Access Compliance Report

Public Rights-of-Way

Main Street: **IRVINE_AVE** Cross Street: **UNIVERSITY_DR** Location: **NW**

ADA ID: **SGRK211018112937** Signal Type: **One Push Button-Non APS** Overall Compliance: **No** Severity Scores: **BTN 1: 35** **BTN 2: N/A** **No BTN: N/A**

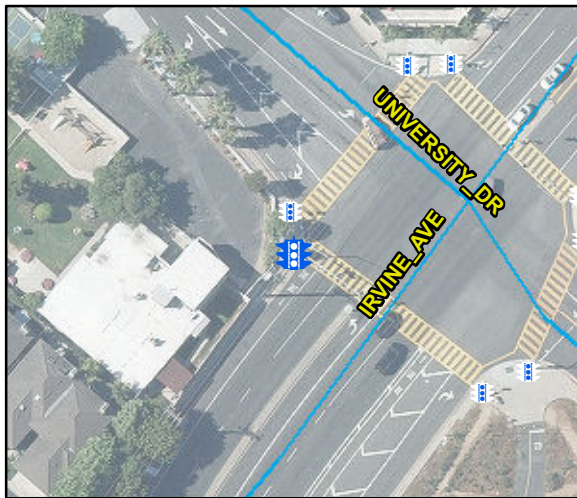
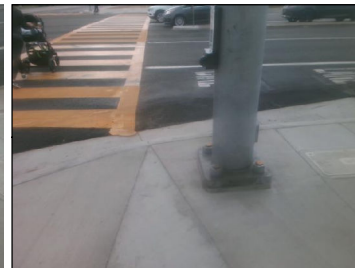
OC Std/PROW: **R404.2, R404.3, MUTCD 4e.08**

Possible Solutions: Replace Signal Push Button With APS Button. Remove and Replace Clear Space.
